MILPITAS PLANNING COMMISSION AGENDA REPORT

TITLE: "S"ZONE APPROVAL NO. SZ 2005-12

Proposal: A request to construct a 5,994 square foot single story residence, detached second family unit, and various landscape amenities including a patio cover, in ground pool, and spa.

Location: 1000 Piedmont Road (APN 88-44-099)

EROSION CONTROL PLAN

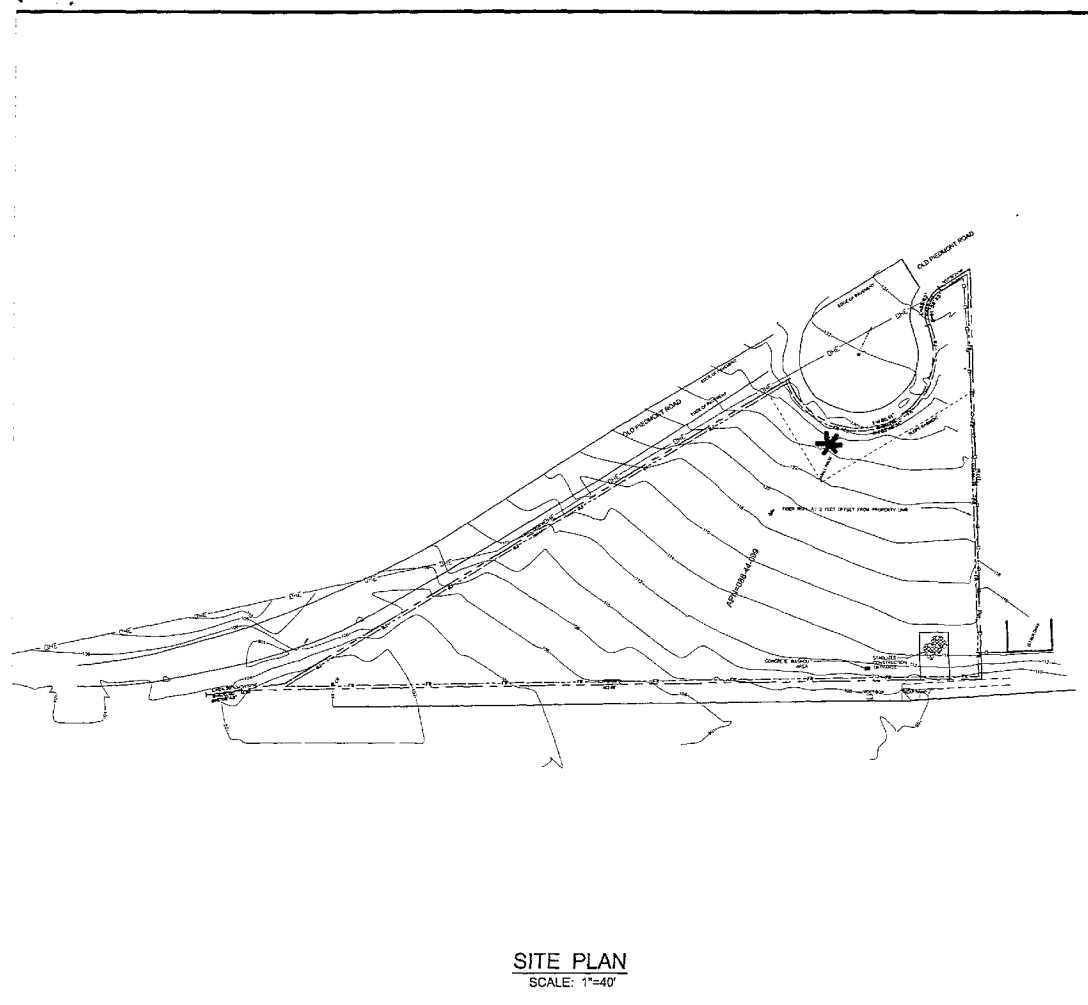
A: COA #13 is a standard condition of approval for projects that involve construction activities and is limited to the project site. As shown in the erosion control plan, sheet C-6, fiber rolls shall be installed around the perimeter of the site to prevent erosion and runoff from spilling onto public right-of-ways and receiving storm drain facilities. The erosion control plan also shows a designated area for construction entrance and a concrete wash out area. Therefore, mud will not be tracked offsite. Any stock piling of topsoil shall be done in conformance with the standard guidelines for stormwater and urban runoff pollution prevention. Therefore, any potential runoff or erosion onto Piedmont is mitigated and less than significant.

13. The applicant shall submit an erosion control plan to the approval of the Planning Division. Erosion control measures shall be in place prior to the start of any work and maintained until the completion of construction. (P)
